## Proposal for amendments to document GRSG/2023/11 (Supplement 2 to the Original Version of UN Regulation No. 160 (Event Data Recorder))

The text reproduced below was prepared by the expert from the International Organization of Motor Vehicle Manufacturers (OICA) to adapt the introduction of new verification procedures to the original version of the regulation. The modifications to the current text of the proposal by the IWG on EDR/DSSAD (see document ECE/TRANS/WP.29/GRSG/2023/11) are marked in blue bold for new and blue strikethrough for deleted characters.

Corridor  $\pm 10$  Per Cent of the Full Scale Range of the Accelerometer

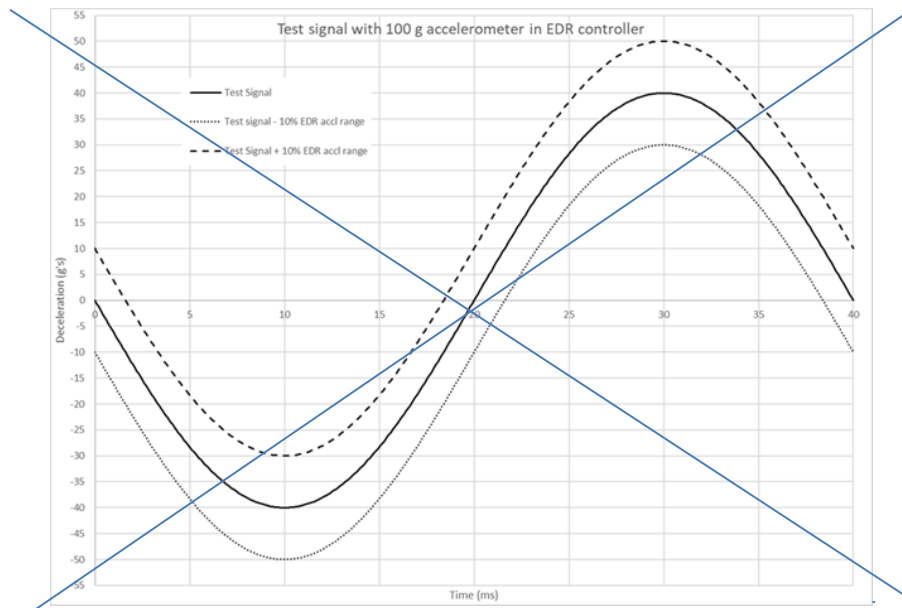
6.1.5. The EDR recorded acceleration trace shall be fully contained in a corridor that is  $\pm 10$  per cent of the full-scale range of the accelerometer used by the controller containing the EDR applied to the component test fixture's filtered acceleration trace. The comparison of acceleration sensor traces shall only be made on the axis the component test was conducted.

For example, if the accelerometer in the controller containing the EDR function has a  $\pm 100$  g range, then  $\pm 10$  g would be applied to the component test fixture's filtered acceleration trace. The EDR recorded acceleration trace shall be fully contained within that corridor (see the Figure).
